**Review of floodplain harvesting modelling submissions – Macquarie modelling**

**Macquarie modelling submissions**

**Figure 1.** *Budyko curves and representative results for Macquarie Valley (S. Podger pers comm 23/12/20)*

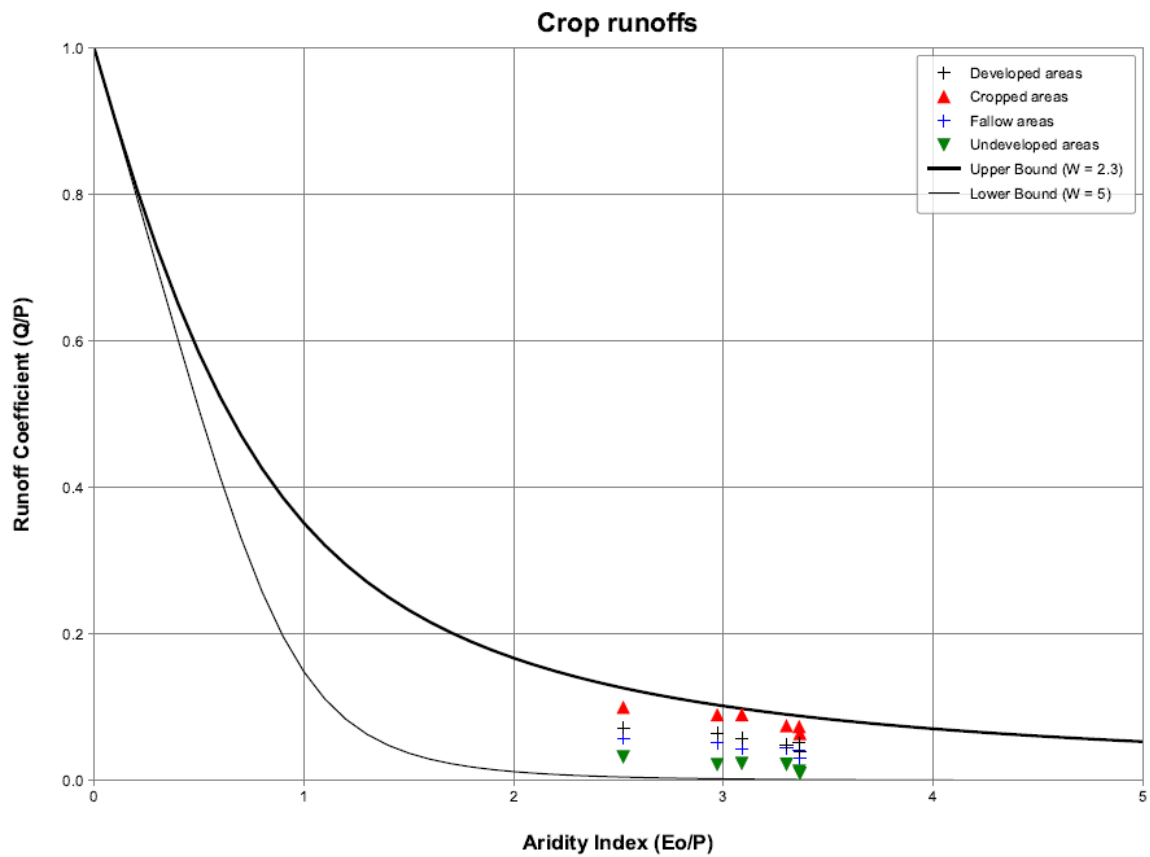
A total of 27 submissions were received and evaluated by the modellers for this valley. I noted that additional rainfall runoff calibration was undertaken and spoke with Scott Podger, the lead modeller, on this. From these discussions and further information provided by Scott, the revised rainfall runoff calibration is consistent with previous work in the Border Rivers and Gwydir to ensure that the runoff estimates are consistent with the Budyko curves for the conditions of the valley, as shown in Figure 1 below. Further, we also discussed the noted changes to the IQQM model regarding how floodplain harvesting occurred on some properties and am satisfied that these changes are appropriate.
